Re: Naval Air Warfare Center (NAWC), Warminster, PA

Please find below initial EPA comments on a Proposed Subsurface Soil Investigation for Area A, as submitted by Brown & Root Environmental and dated September 7, 1995. Per our discussions, these initial comments address the eastern portion of Area A identified on the enclosed map (see Figure 1). This eastern portion of Area A includes the following features identified by EPA-EPIC: Probable Trench TR1, Ground Scar GS1, Possible Trench TR2, Mounded Material MM1 and Disturbed Ground DG1. This area also includes "Site 3" and parts of "Site 2" as described in previous RI reports. As discussed, based on the photo review and interpretation by EPA-EPIC, these "sites" virtually contiguous.

Figure 2
(letter of 10/16/95)

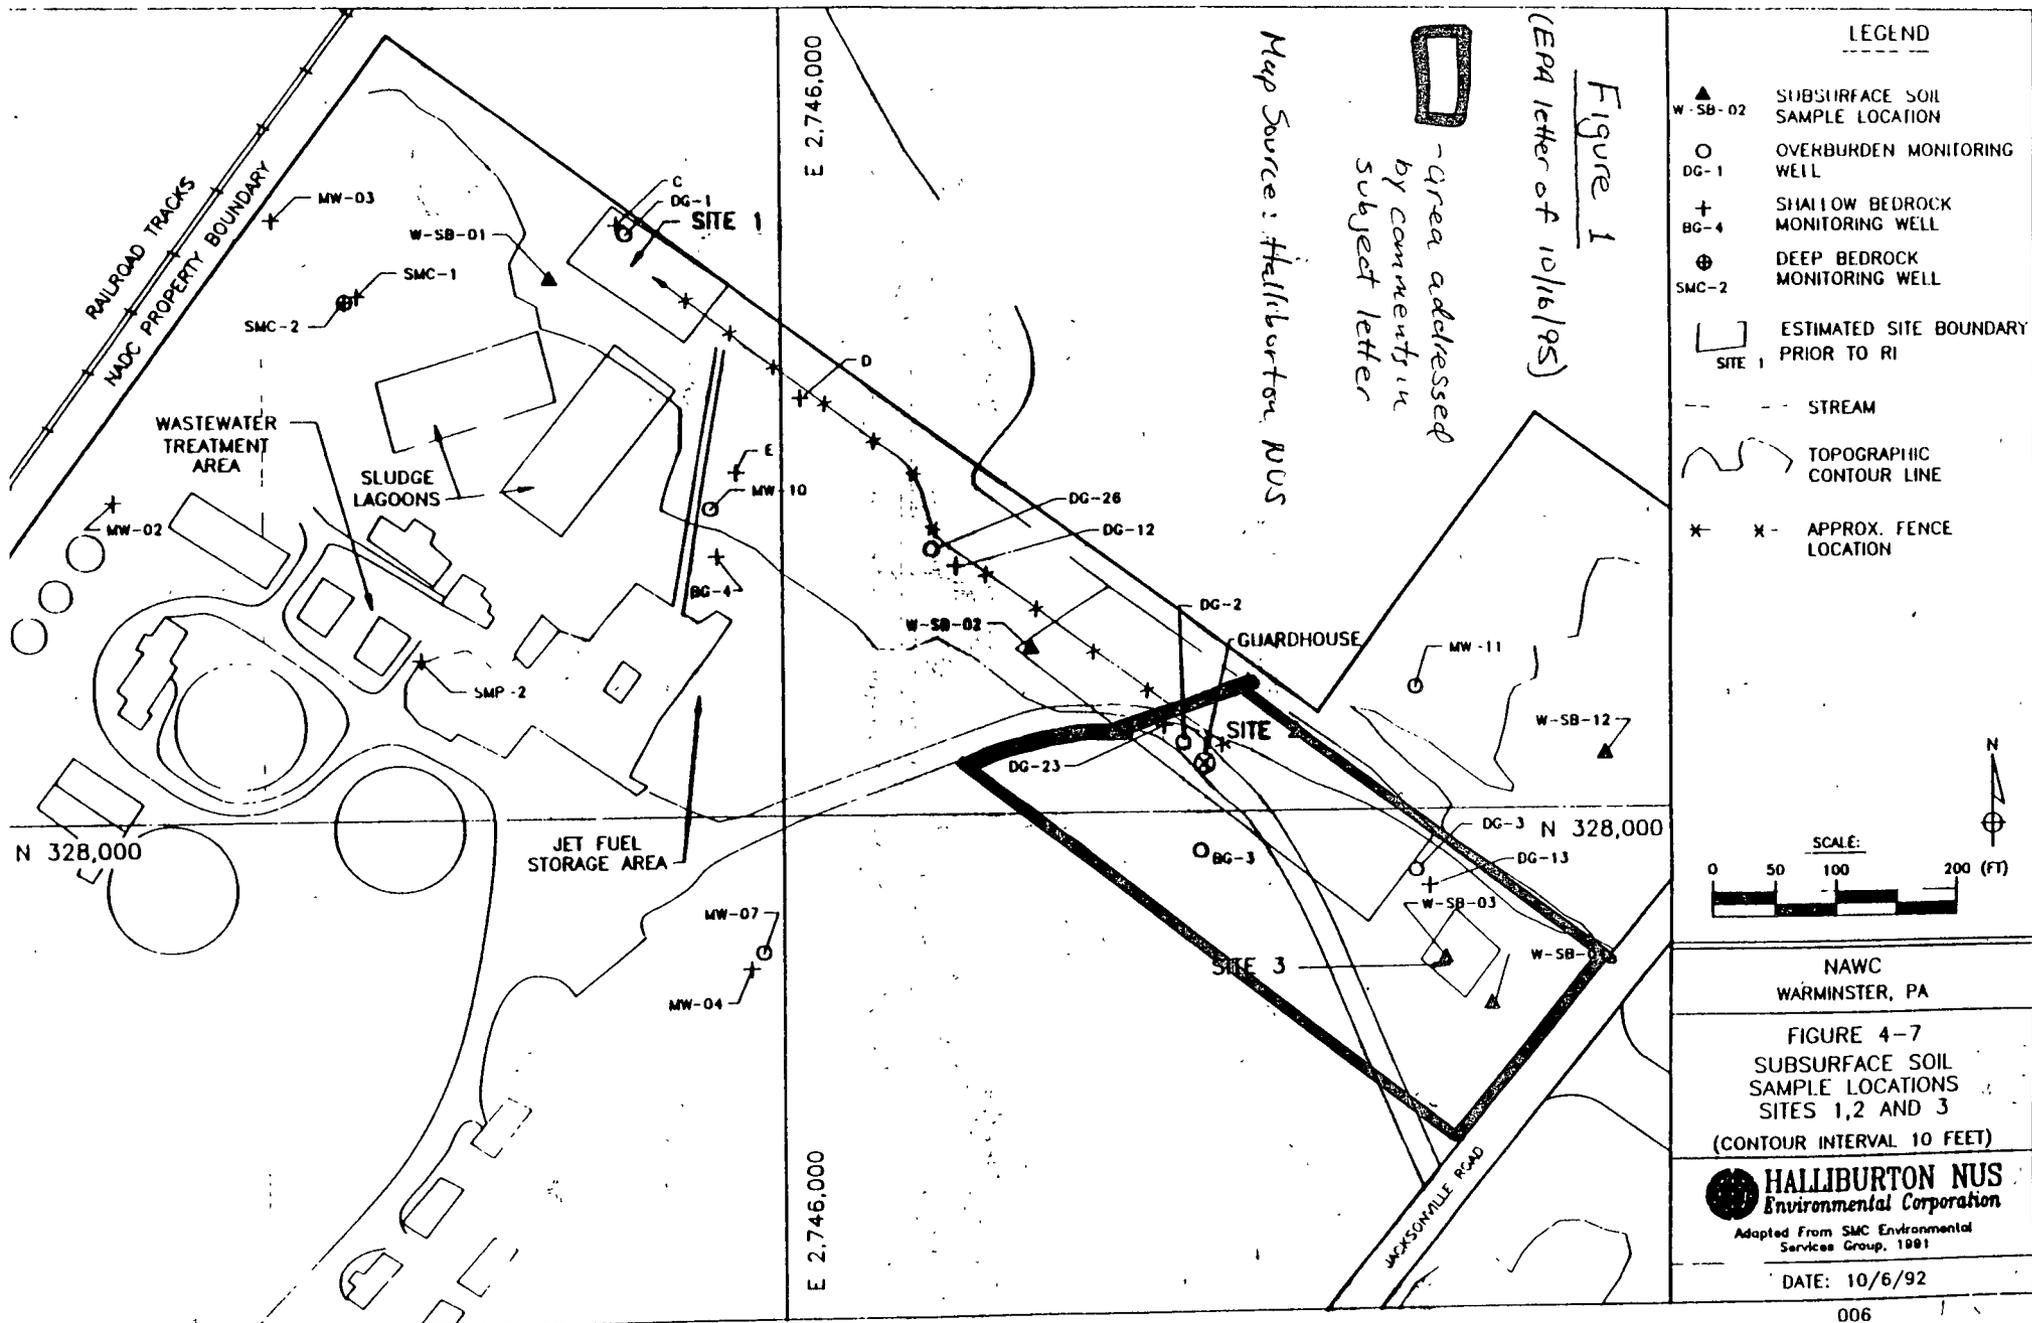
Based on RI data generated to date, identified below are the significant features of concern in the subject area and the subsurface soil sampling recommending to investigate these features (Figure 2 indicates the location of the soil borings and test pits referenced below). Note that, to date, only one subsurface soil sample has been collected and analyzed for TCL/TAL parameters from the features identified below.

1. VOCs ranging from 2 to 20 ppm were detected by HNu from 2 to 10 feet in depth in Soil Boring S3-3 during the Phase I RI. The location of this boring may potentially correspond to EPIC feature D1, the location of an alleged "burn pit", and a geophysical anomaly identified during the Phase I RI. In response, a test pit (TP1) should be conducted at this location and a soil boring (SB1) conducted about 25 feet downdip.
2. A gray, apparent sludge-like material with HNu readings ranging from 1 to 2 ppm was encountered from 3 to 8 feet in depth in Soil Boring S3-1 during Phase I RI. A soil boring (SB2) should be conducted at this location.
3. A significant geophysical anomaly was detected at the location of Possible Trench TR2. The aerial photo of

9/23/58 indicates this possible trench was approximately 125 feet long. During the Phase II RI, TCE was detected at 16 ppb in MW DG-23 and manganese was detected at 4190 ppb manganese in MW DG-2. These wells may be downgradient of TR2. To investigate TR2, two soil borings (SB3 and SB4) should be conducted through the access road and two test pits (TP2 and TP3) conducted south of the access road.

4. No exploratory soil borings were conducted between D1 and TR2 during the Phase I or Phase II RI. An aerial photo dated 9/23/58 indicates significant soil disturbance in this area. Two soil borings (SB5 and SB6) should be conducted through the access road between D1 and TR2.

5. Mounded material was noted to be present immediately west of TR2 in the photo of 9/23/58 (see MM1) and a photo dated 3/31/65 (see MM3). Soil borings should be conducted within the area of MM1 (see SB7) and MM3 (see SB8).

6. Benzene was detected in soil gas at levels of up to 1510 ppm at three consecutive sample stations along the fence line about 100 to 150 feet east of the guardhouse. Two soil borings (SB9 and SB10) should be conducted within this area.

7. Benzene levels of up to 510 ppb were detected in soil gas at a series of 10 sample stations along the access road west of the guardhouse. Three soil borings (SB11, SB12 and SB13) should be conducted at 25 foot intervals in the area of the highest soil gas readings.

8. No soil investigation to date has been conducted at the location of Probable Trench TR1 or Ground Scar GS1. These features may be located upgradient of the elevated benzene levels detected in soil gas along the access road west of the guardhouse. Three soil borings (SB14, SB15 and SB16) should be conducted at the estimated location of TR1/GS1 to try and locate these features and one boring (SB17) should be conducted between these features and the referenced soil gas stations along the access road.
